WILLIAMSON COUNTY, TEXAS

CHANGE ORDER NUMBER: 1

Project: 11WC906

Roadway: O'Connor Dr Ext.

O'CONNOR DR. & GREAT
OAKS DR. AT RM 620
O'CONNOR DR.
EXISTING UTILITY LAYOUT

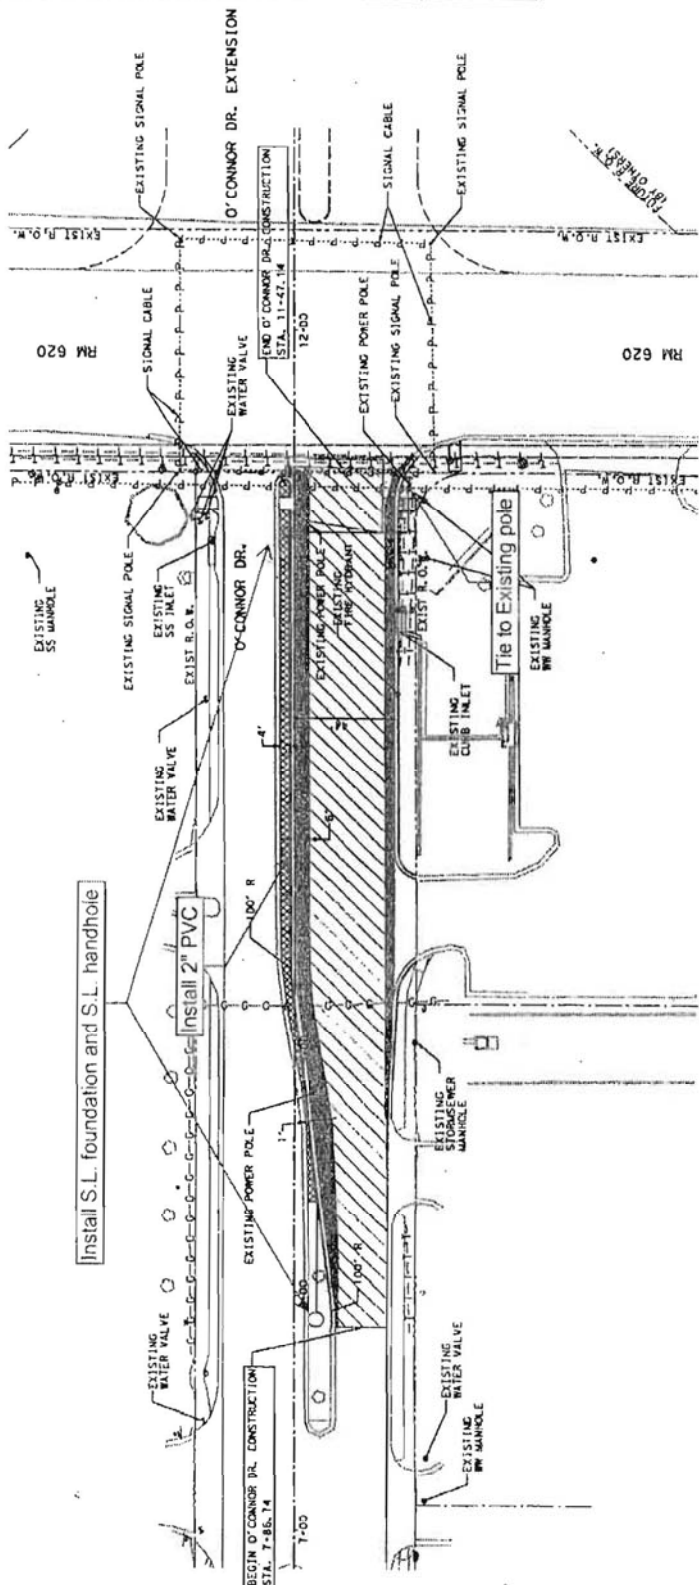
6C: Untimely ROW/Utilities. Utilities not clear. This Change Order provides payment to the Contractor to relocate the existing safety lighting (2 poles) and conduit to a new location out of the way of the roadway improvements in the newly reconstructed center median on O'Connor Drive, north of RM 620.

This Change Order provides payment to the Contractor to relocate two existing light poles and existing conduit in conflict with the construction of the intersection improvements on O'Connor Drive, north of RM 620. The conflict was created by the design of the new additional left turn lane which is being added through a reduction in the width of the center median. The light poles will be relocated to the newly reconstructed narrow center median on O'Connor Drive.

Items	Qty
2" Schedule 40 conduit w/ 2500 lb. pull tab	450'
Foundation	2
Pull Box	2
